Enclosed are eight copies of revised pages to the SARR for the T-2 Shipping Package, USA/5607/9F (DOE-CORO). This supplements the information we forwarded to you June 20, 1980.

Subject: Submittal of Revised Pages to the Safety Analysis Report (SAR) for the T-2 Shipping Package

SUPPLEMENT NO. 1  
SAFETY ANALYSIS REPORT  
T-2 Shipping Package

SUPPLEMENT NO. 2  
SAFETY ANALYSIS REPORT  
T-2 Shipping Package

FIGURE 1.2 T2 SHIPPING CASE COMPONENTS

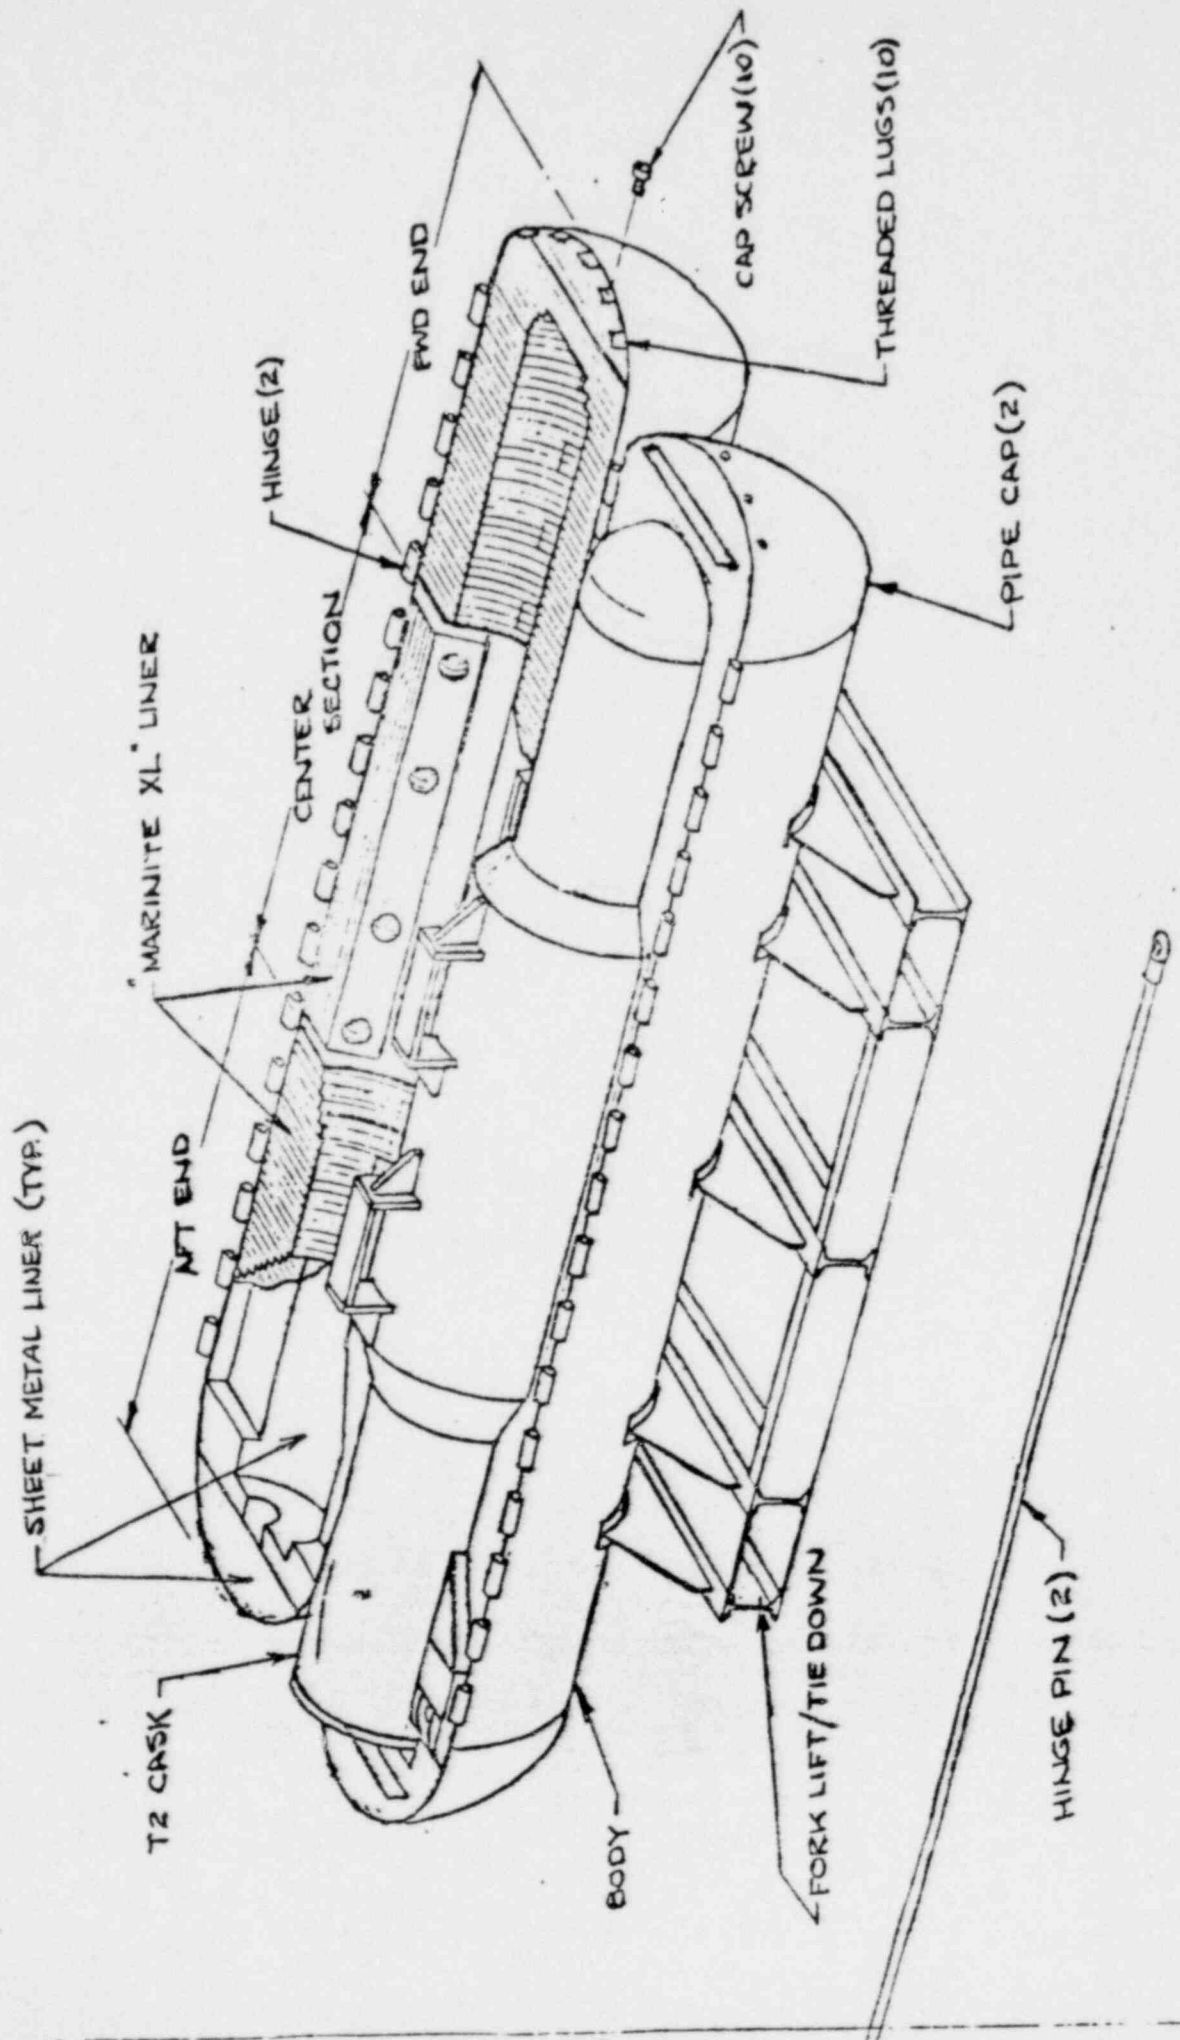
This supplement to the April 1980 Safety Analysis Report (SARP) for the T-2 Shipping Package covers the addition of a stainless steel, sheet-metal liner inside the shipping case. The sheet-metal liner serves to protect the "Marinite" insulation from physical damage and contamination during normal loading and unloading operations.

A 16-gauge (0.0625-in. thick) stainless steel, sheet-metal liner inside the shipping case protects the "Marinite" from physical damage and possible contamination during normal loading and unloading operations. A 1/8-in. clearance is maintained between the sheet-metal liner and the cask, except at the cone-shaped end plates. Fig. 1.2 shows the principal elements of the T-2 shipping case.
